6.1 **480/2020 - 141 ACLAND STREET, ST KILDA VIC 3182**
LOCATION/ADDRESS: **141 ACLAND STREET, ST KILDA VIC 3182**
EXECUTIVE MEMBER: **KYLIE BENNETTS, GENERAL MANAGER, CITY GROWTH AND DEVELOPMENT**
PREPARED BY: **MARTIN COOKSLEY, SENIOR URBAN PLANNER**

- 1.1 To consider and determine application P480/2020 for partial demolition, alterations and additions; the construction of ground, first and second floor levels to an existing commercial building and the reduction of car parking requirements at 141 Acland Street, St Kilda.

Figure 2. Proposed three storey addition to rear of the existing building.

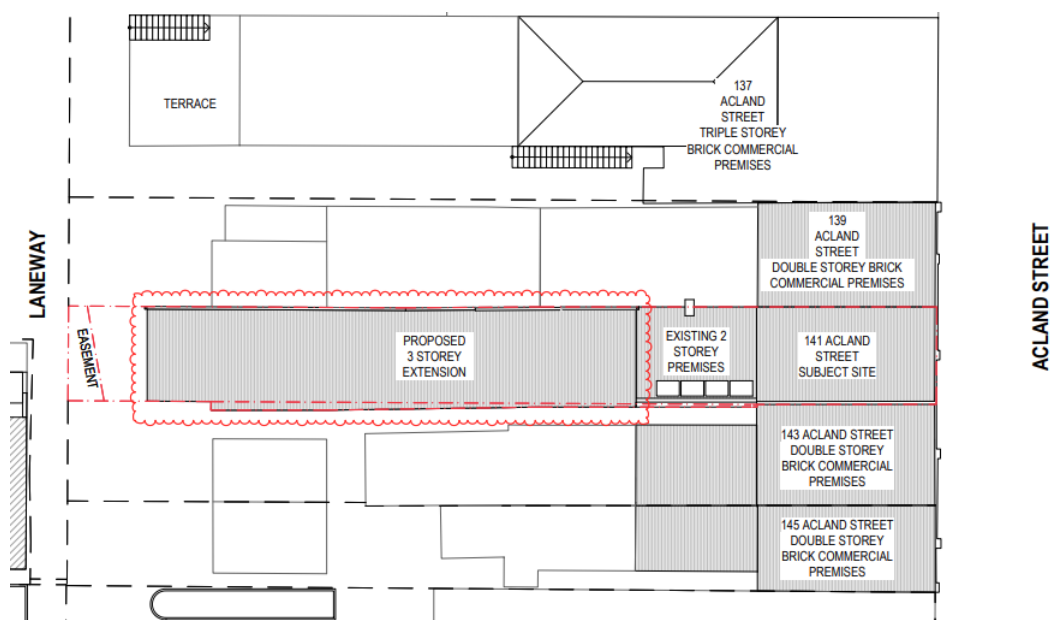
The proposal notes that the first and second floor windows located to the rear façade would be fixed and fitted with obscured/opaque glazing to a height of 1.7 metres above FFL to ensure there would not be unreasonable overlooking to adjoining and adjacent residential properties. No further screening is therefore required.

With regard to amenity impacts, there would be an impact of overshadowing to the adjoining terrace contained at 143 Acland Street. Whilst the proposed extensions would create additional shadow over the terrace from 1pm, it is not considered to be unreasonable given the residential dwelling is contained within a commercial zone and given the expectation of amenity should not be the same as those properties in land zoned for residential purposes. In addition to this, to the rear, the sites fronting Chaucer Street (located in a residential area) would not be unreasonably affected by any shadow cast by the proposed development. The rear of 20 Chaucer Street would receive an additional 8sqm of additional overshadowing at 9am and would not be affected thereafter. With regard to overlooking, the proposal would include screening to the first and second floor windows located to the rear façade in the form of opaque glazing (fixed shut) to a height of 1.7 metres above FFL. This would ensure there is no unreasonable
